SECTION: 417

Service Action: Left-Hand and Right-Hand Rear Lamps LED Failure

XF (X250)

VIN: R00001 - R61290
Model Year: 2009 - 2010

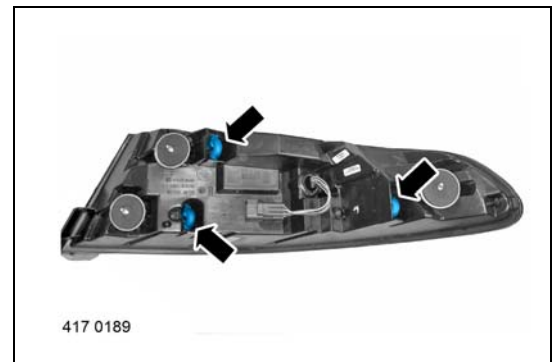
1. Turn the exterior lights 'ON'.
 - If the left-hand (LH) lamp assembly LEDs are functioning correctly, perform steps 2-4 and 6 below only.
 - If the LH rear lamp assembly LEDs are not functioning correctly, perform steps 5-6 below only.
2. Refer to Workshop Manual, section 417-01: *Exterior Lighting*, and remove the LH rear lamp assembly.
3. Replace the vent tubes:
 - Release and remove the three (3) vent tubes from the lamp assembly.
 - Install three (3) new vent tubes to the lamp assembly.

4. Refer to Workshop Manual, section 417-01: *Exterior Lighting*, and install the LH rear lamp assembly.

**NOTE: New lamps do not require vent tube installation.**

5. Refer to Workshop Manual, section 417-01: *Exterior Lighting*, and replace the LH rear lamp assembly.
6. Repeat steps 1-5 to the right-hand (RH) rear lamp assembly.
